From: Casey, Colleen [<mailto:Colleen.Casey@nrc.gov>]
Sent: Thursday, November 01, 2012 7:16 PM
To: Wroblewski, Edward
Subject: Second deficiency, different letter

Re: USNRC Materials License No. 13-00133-02; CONTROL No.: 578158

With regard to the request for additional information regarding the leak test performed on on the Nucletron HRD unit formerly located at St. John's Hospital, Anderson, IN.

~~#1~~ Indexer on HDR unit

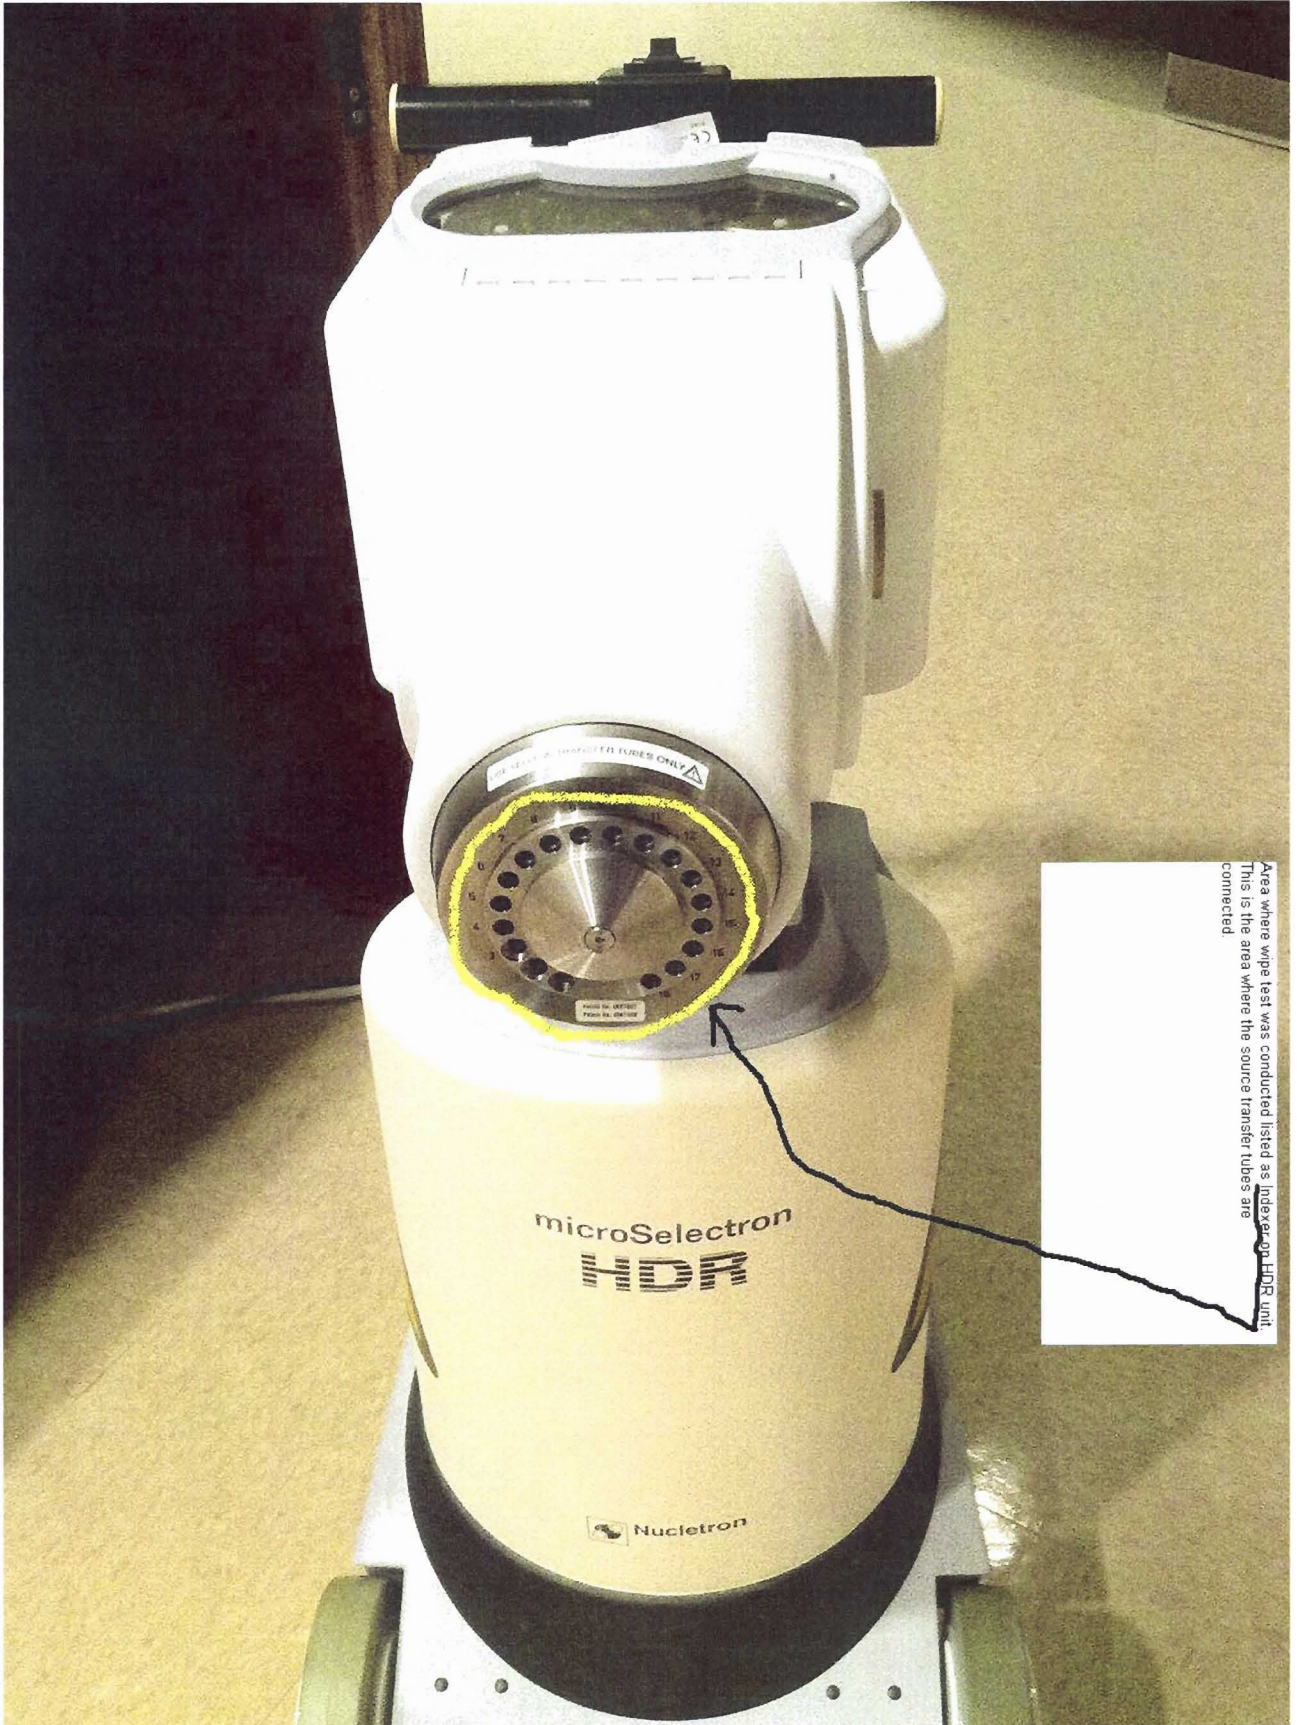
Area where wipe test was conducted listed as Index group HDR unit.
This is the area where the source transfer tubes are connected.

HDR Belt drive Area

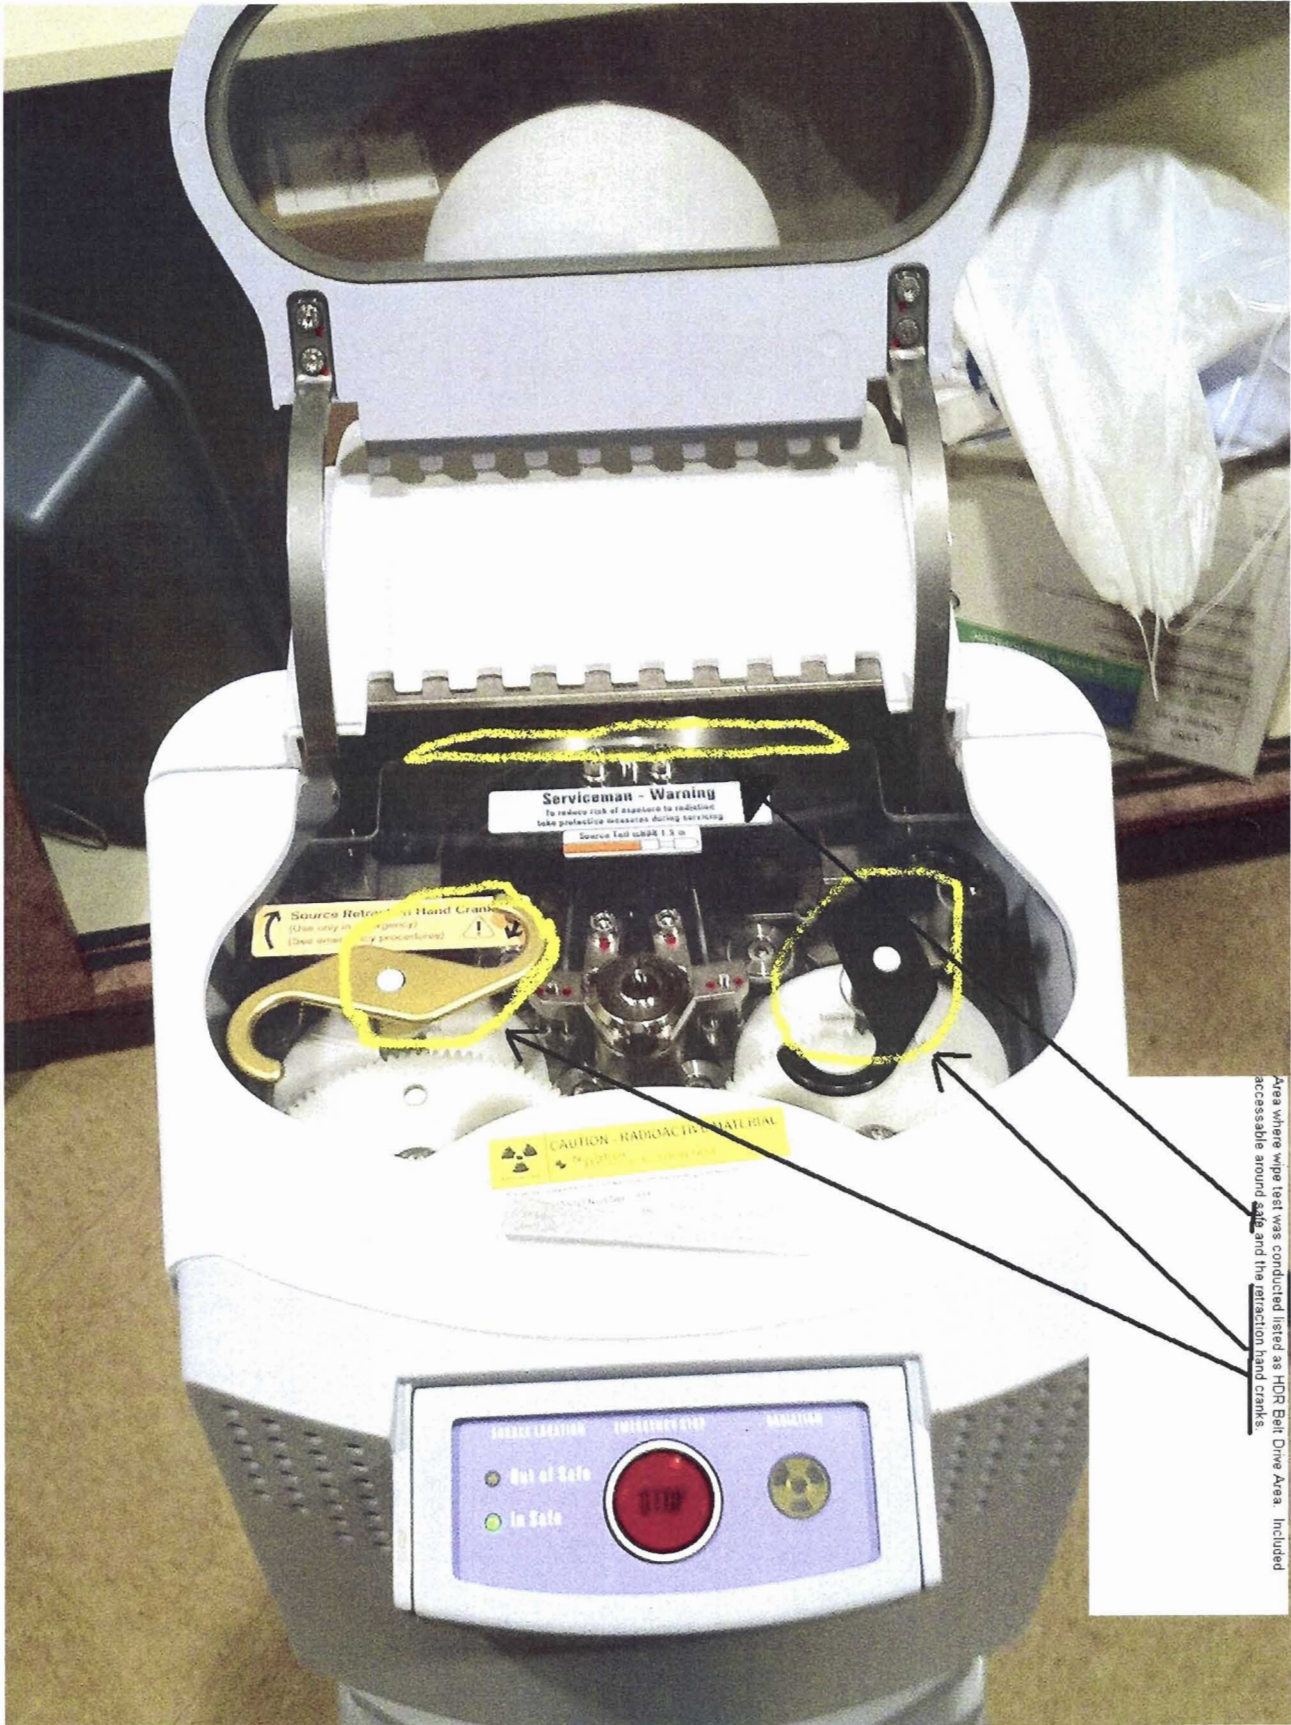
Area where wipe test was conducted listed as HDR Belt Drive Area. Included accessible around safe and the retraction hand cranks.
